USC Aiken Pedestrian Safety Improvements  
Addendum No.2 Items – 3/2/2012

USC Aiken Pedestrian Safety Improvements  
Project No. H29-I332

E102 PARTIAL PLAN  
3/1/2012

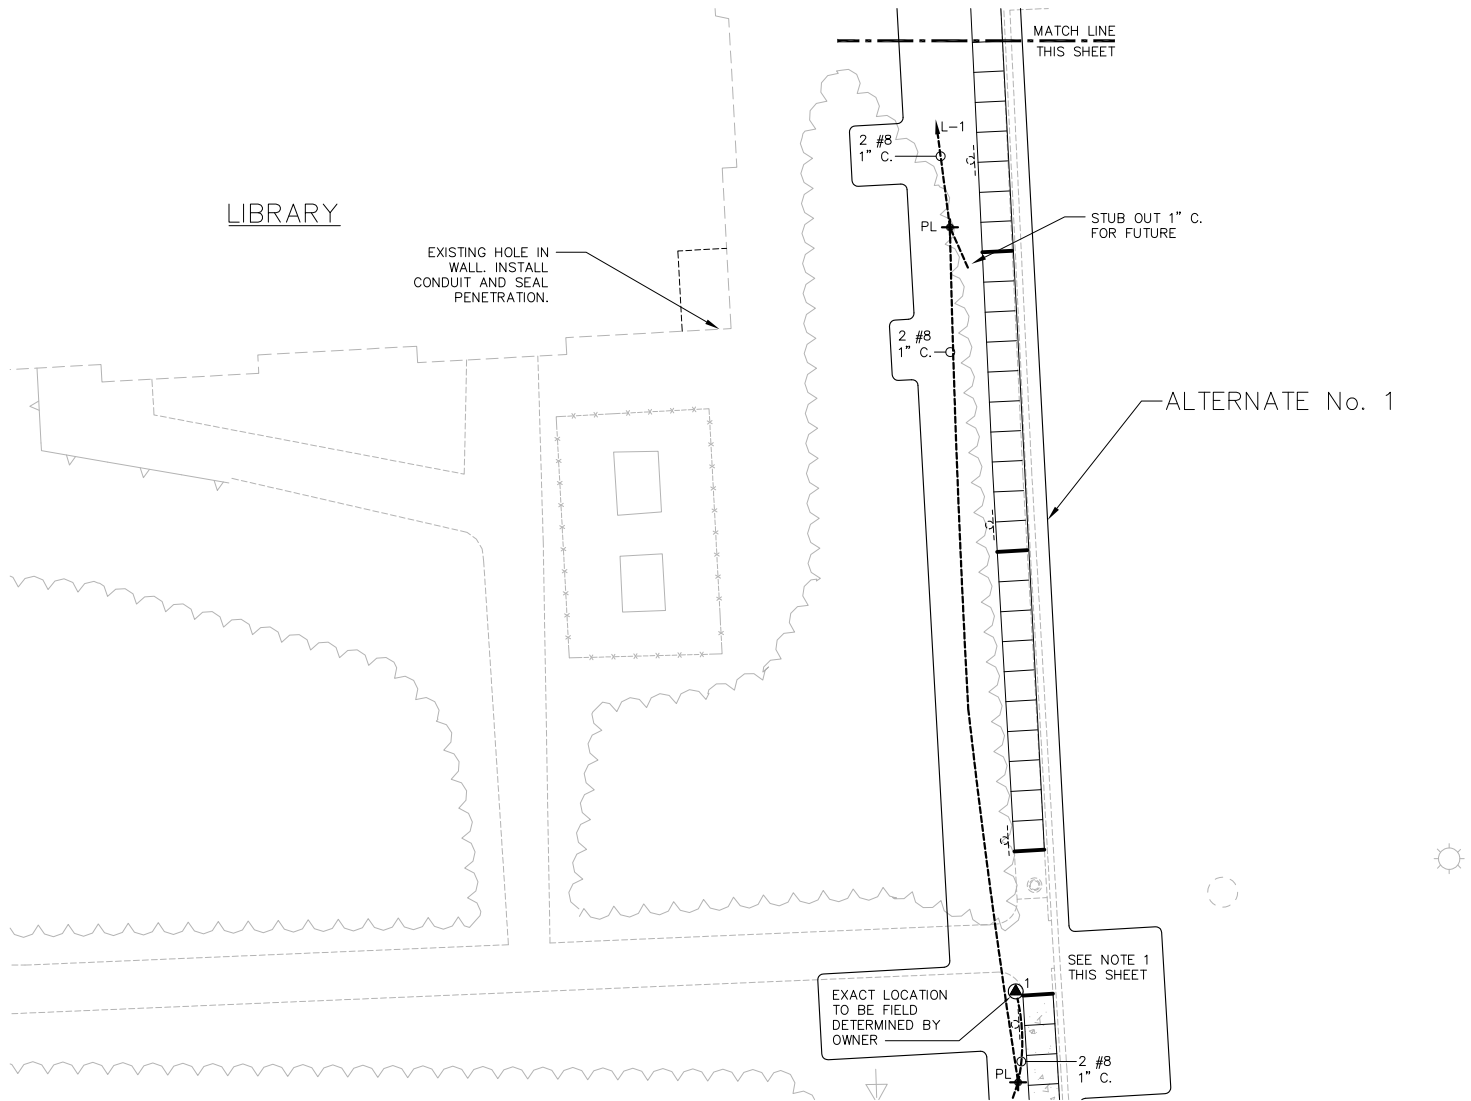
**Item#5-**For Emergency Call boxes, eliminate stub-out conduits for communications.

Install 3/4" conduit from the electrical room in the basement of the Library (see attached E102 Sketch for location) and route a Category 3 four-pair UTP, wet rated, cable to a Quazite A47101512A (or equal) handhole next to the Alternate No. 1 call box location shown on E102 (for future connection to said call box). Provide six feet of slack coiled and unterminated inside basement of library electrical room. In handhole, splice the cable to two additional category 3 four-pair UTP, wet-rated, cables to be routed to the other two call boxes shown on E101 and E103. Provide same length of slack in handhole for all three cables to allow for connecting to future (Alternate No. 1) call box. All cables shall be in 3/4" Conduit and, where possible, routed alongside power conduit in the same trench. Provide TEE connection in raceway at Pacer Downs roadway. For crossing Pacer Downs, push and bore under the road.

Note: Price for work for ALTERNATE NO. 1 should take into account a credit for NOT installing a separate handhole, but instead pulling communications cable directly to call box shown on E102 with no cable slack in call box.
